Flight Procedures Cover Page	Task Action: FLIGHT CHECK	Task Type: IAP	Estimated Chart Date: 11/03/2022	APWS Task ID: 238812AE563C42428A891E0AE3BE472E	APWS Project ID: BE76F97A33FE456E9E9230D206A33B88
Procedure: ILS OR LOC RWY 27 AMDT 6		Enroute: NO	Specialist: Sweeting, Dexter		Agreement Number:
Airport ID: KRYY			Airport City: ATLANTA		State: GA
Facility ID: RYY	Facility Type: ILS	Flight Inspection Remark Type: New FC Slot			
<p>Procedure Comments: ACTIVE DATA USED FOR KRYY AIRPORT AND RUNWAYS; PENDING DATA USED FOR I-RYY NAVAID.</p> <p>PDK VOR MON.</p> <p>INSTALLATION OF DME TO I-RYY NAVAID.</p> <p>CONTACT: DONALD LANIER 405-954-8242.</p> <p>09/26/2022: THIS IS A CORRECTED COPY OF THE FORM APPROVED ON 06/23/2022.</p> <p>1. PROFILE LINE 4: REMOVED (*) FROM CUMAV/I-RYY 2.89 DME.</p> <p>2. NOTES: REMOVED *1680 WHEN USING JACKSON ATLANTA INTL ALTIMETER SETTING AND MOVED TO BACK OF -9.</p> <p><i>Digitally signed by</i> ERIC N SUSKI Sep 26, 2022</p>

ILS or LOC RWY 27
COBB COUNTY INTL/MCCOLLUM FLD (RYY)

KRYV
COBB COUNTY INTL/MCCOLLUM FLD
ATLANTA, GA
ILS OR LOC RWY 27 AMDT 6
CIRCLING
1:100K

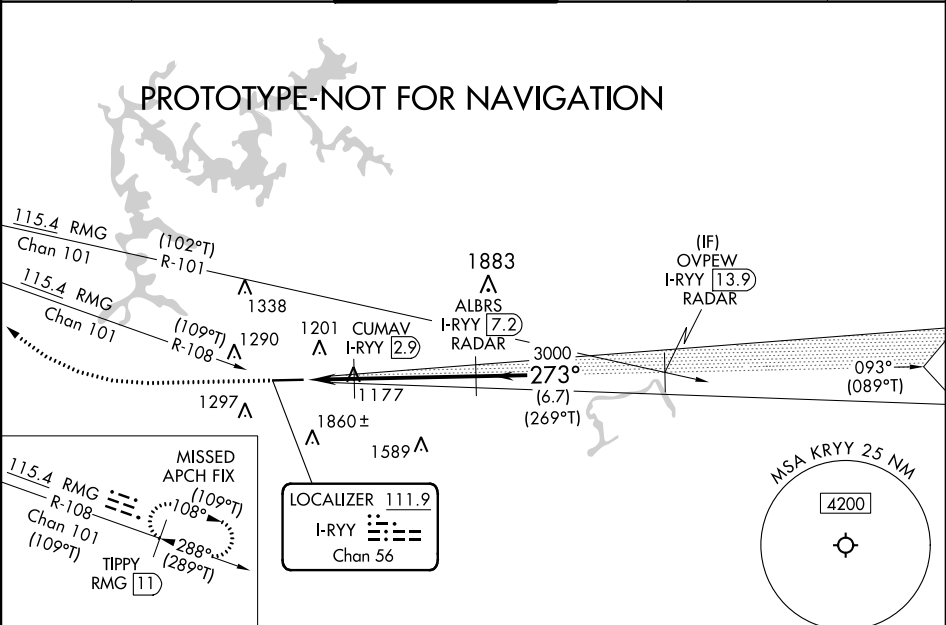
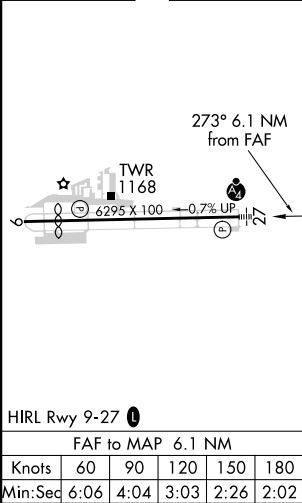
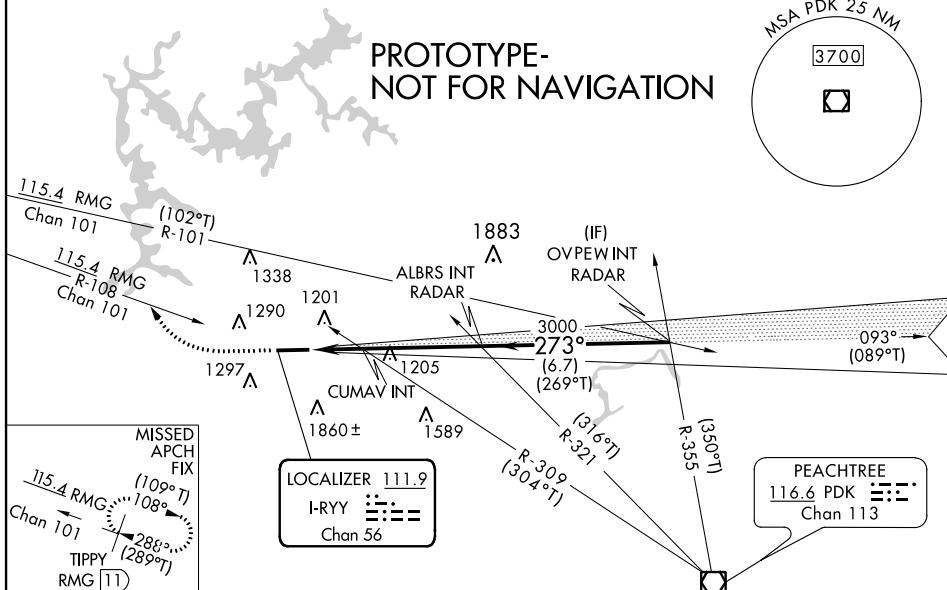
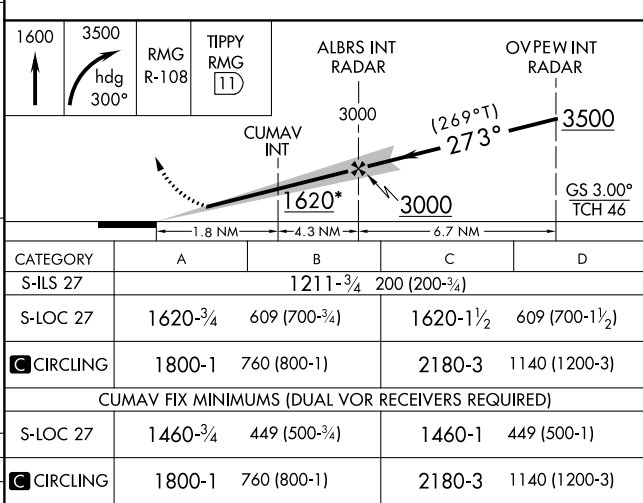
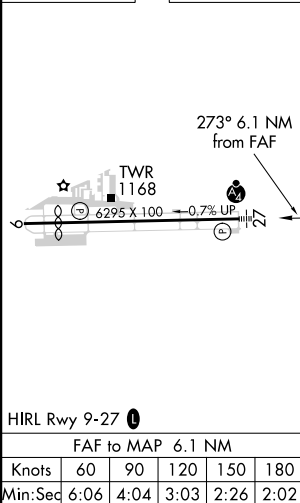
Flight Procedures Cover Page	Task Action: FLIGHT CHECK	Task Type: IAP	Estimated Chart Date: 11/03/2022	APWS Task ID: 238812AE563C42428A891E0AE3BE472E	APWS Project ID: BE76F97A33FE456E9E9230D206A33B88
Procedure: ILS OR LOC RWY 27 AMDT 6		Enroute: NO	Specialist: Sweeting, Dexter		Agreement Number:
Airport ID: KRYY			Airport City: ATLANTA		State: GA
Facility ID: RYY	Facility Type: ILS	Flight Inspection Remark Type: New FC Slot			
<p>Procedure Comments: ACTIVE DATA USED FOR KRYY AIRPORT AND RUNWAYS; PENDING DATA USED FOR I-RYY NAVAID.</p> <p>PDK VOR MON.</p> <p>INSTALLATION OF DME TO I-RYY NAVAID.</p> <p>CONTACT: DONALD LANIER 405-954-8242.</p>

Procedures to be amended due to ATL and PDK VOR decommissionings. RNAVs added due to shared fix/ and optimize procedure design, add TAAs.

▼ Inoperative table does not apply to S-ILS 27. For inoperative ALS, increase S-LOC 27 Cats C and D visibility to $1\frac{3}{8}$

*1680 when using Jackson Atlanta Intl altimeter setting.
